Rezoning Application: RZ PD 26-0328

Zoning Hearing Master Date: April 27, 2026

AGENCY REVIEW COMMENT SHEET

PETITION NO: RZ 26-0328

Exhibit B - Site Plan

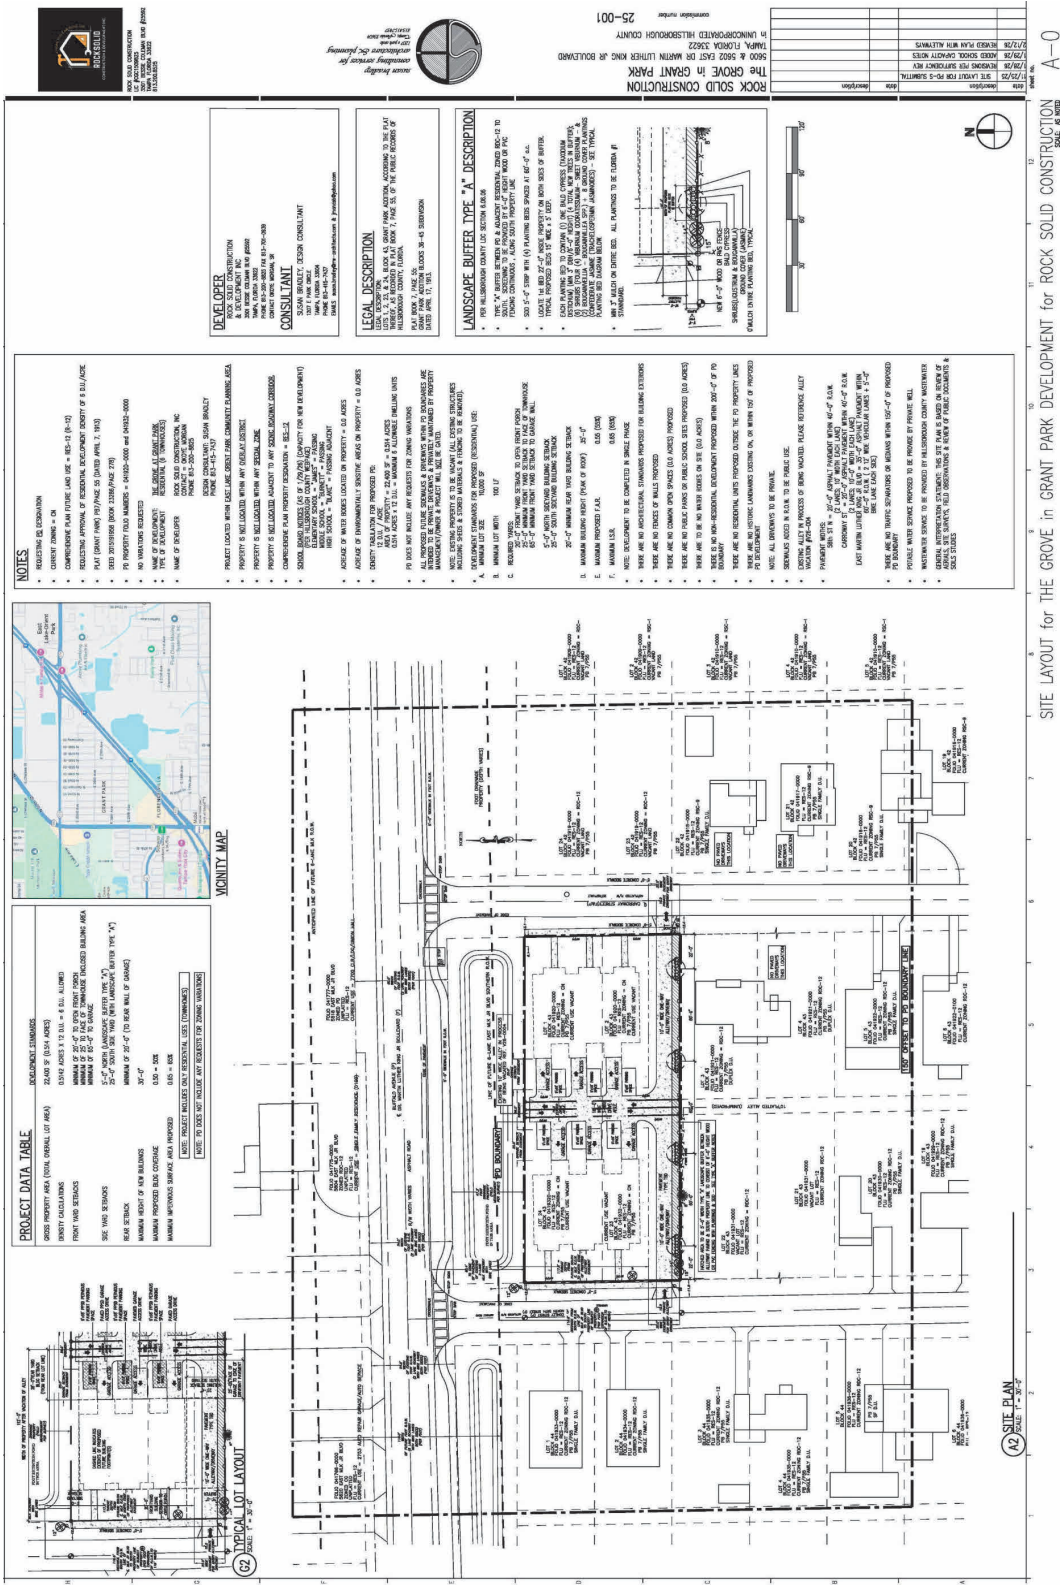
- Section 6.04.07 to provide access on N 58th Street to the proposed development.
 - The proposed driveway location does not meet Hillsborough County minimum spacing requirements.

Although the proposed access does not meet the Hillsborough County minimum access spacing of 125 feet, relocating the proposed access is not feasible. The parcel has approximately 100 feet of frontage on N 58th Street. The proposed access is shown at the south end of the property (see **Exhibit B**). Relocating the proposed access to meet spacing standards requires right of way outside the applicant's parcel.

The proposed one-way alley is essential for both access to the site and internal circulation.

I have found the attached two Section 6.04.02.B. Administrative Variances (AV) for PD 26-0328 APPROVABLE.
